Re: WesPac Pittsburg Energy Infrastructure Project, Recirculated Draft Environmental Impact Report (RDEIR), SCH #2011072053

Communities for a Better Environment (CBE) joins in the comments of the Natural Resources Defense Council on the above cited project and RDEIR and respectfully submits these additional comments focused on the project's implications for climate protection. CBE respectfully requests written responses to each of our comments, including those we join in via separately submitted documents, and those herein.

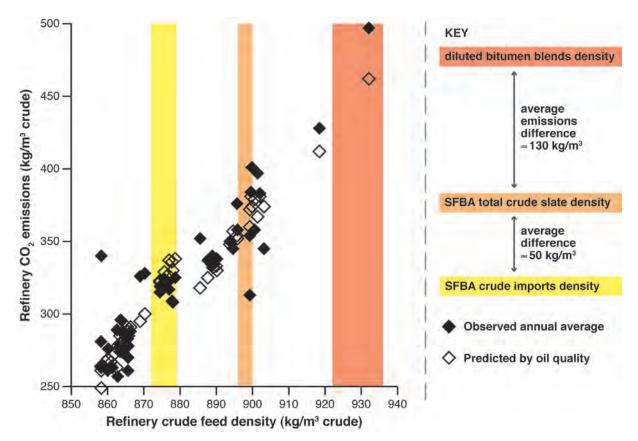
Chart 1 shows annual average observations (black diamonds) and predictions based on crude feed density and sulfur content (white diamonds) from the four largest U.S. refining regions, California, and the San Francisco Bay Area (SFBA). Refinery CO₂ emissions are plotted against refinery crude feed density. The diagonal rise of these 52 observations from left to right in the chart indicates increasing emissions with increasing crude feed density. Emissions nearly double, from $\approx 260-500 \text{ kg/m}^3$ crude refined, as crude density increases from $\approx 860-930 \text{ kg/m}^3$. The alignment of predicted and observed values further illustrates that crude quality is driving these differences in average emissions among refining regions and years, allowing the prediction of average emissions based on crude feed quality (more detailed findings attached¹⁰).

The vertical yellow band toward the left in the chart shows the range of annual average density for imported crude oils refined in the SFBA from 2010–2012.¹¹ The broader light-red band toward the right shows the range of densities for several diluted tar sands bitumen blends¹² that could be transported from Canada via rail to the project and sent by it to Bay Area refineries. The narrower orange or brown band near the middle in the chart shows the approximate weighted average density of the total (foreign imports and domestic) crude slate refined in the SFBA in 2008,¹³ the last year a peer reviewed estimate is available for this value.

Review of the chart reveals large differences in average refinery emissions between the three bands. These differences are summarized to the right of the chart ($\approx 50 \text{ kg/m}^3$ between SFBA crude imports and SFBA total crude slate; $\approx 130 \text{ kg/m}^3$ between SFBA total crude slate and diluted bitumen from tar sands). The chart thus illustrates the evidence indicating that the change in oil feedstock resulting from the project could increase refinery emissions substantially.
